## 4. CASE 21.139, 117 BROADWAY, Commercial Building, 1935 (BROADWAY)

Proposal: The scope of work proposed consists of Major Alterations and includes:

• the modification of the existing building to include the addition of a third floor, new siding and installation of fenestration and balconies to multiple elevations.

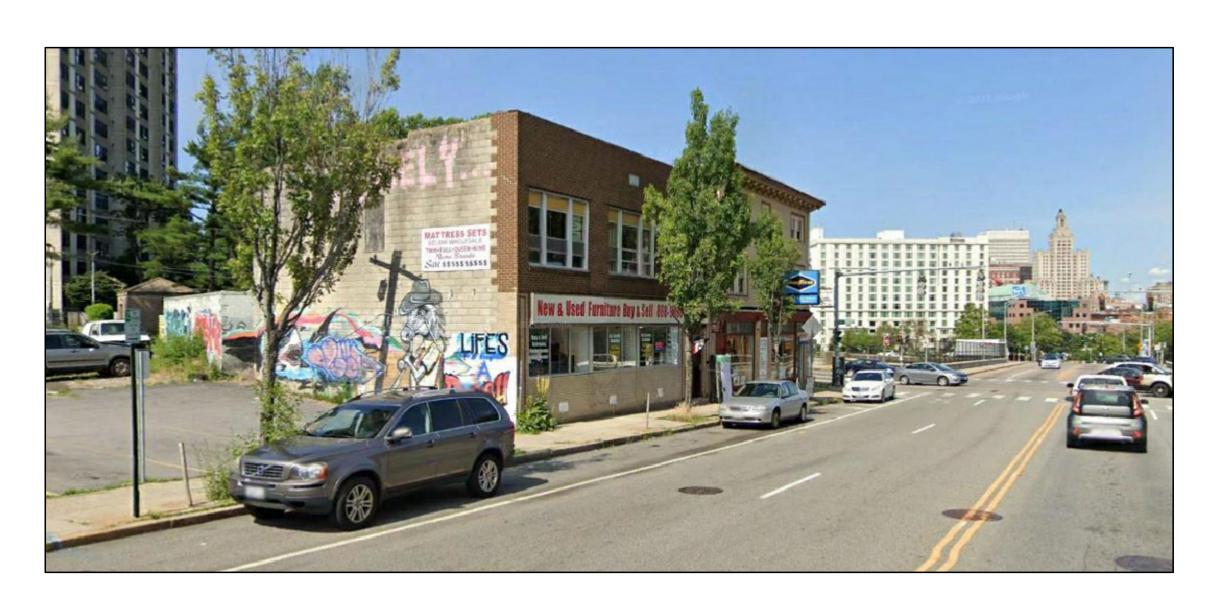
Issues: The following issues are relevant to this application:

- The application is for conceptual approval;
- The building is not included within the Broadway/Armory National Register Historic District. This includes a re-evaluation and expansion of the district that was conducted in 2008;

- Building records identify an addition being constructed and the storefront modified in 1965 (see attached);
- Given the status of the property it is staff's opinion that the modification of this property will not cause an adverse effect on the property or district;

- At the 12/20 meeting the item was continued. The Commission stated concerns about the level of documentation provided. The
  Commission requested existing elevations and a drawing and/or rendering showing the proposed modified building in context
  with the adjacent building. There was feedback regarding the existing modifications with Commissioners commenting that the
  existing front façade should remain intact, while allowing for changes in the storefront; and,

- · Revised plans, renderings and photos have been submitted.

**Recommendations:** The staff recommends the PHDC make the following findings of fact:

- a) 117 Broadway is a structure located within the Broadway local historic district. The property is not included within the Broadway/Armory National Register Historic District, and may be considered non-contributing by the Commission. The Broadway/Armory NRHD was expanded in 2008 when this area of the street was considered for inclusion, but was not added to the NRHD;
- b) The application for Major Alterations is considered complete for conceptual review; and,
- c) The work as proposed is in accord with PHDC Standard 8 as follows: as the proposed alterations are appropriate having determined that the proposed construction is architecturally and historically compatible with the property and district having an appropriate size, scale and form that will not have an adverse effect on the property or district.

Staff recommends a motion be made stating that: The application is considered complete for conceptual review. 117 Broadway is a structure located within the Broadway local historic district. The property is not included within the Broadway/Armory National Register Historic District, and may be considered non-contributing by the Commission. The Broadway/Armory NRHD was expanded in 2008 when this area of the street was considered for inclusion, but was not added to the NRHD. The Commission grants Conceptual Approval of the proposal as submitted having determined that the proposed alterations are appropriate as the proposed alterations are architecturally and historically compatible with the property and district having an appropriate size, scale and form that will not have an adverse effect on the property or district, citing and agreeing to the recommendations in the staff report, with staff to review any additional required details.
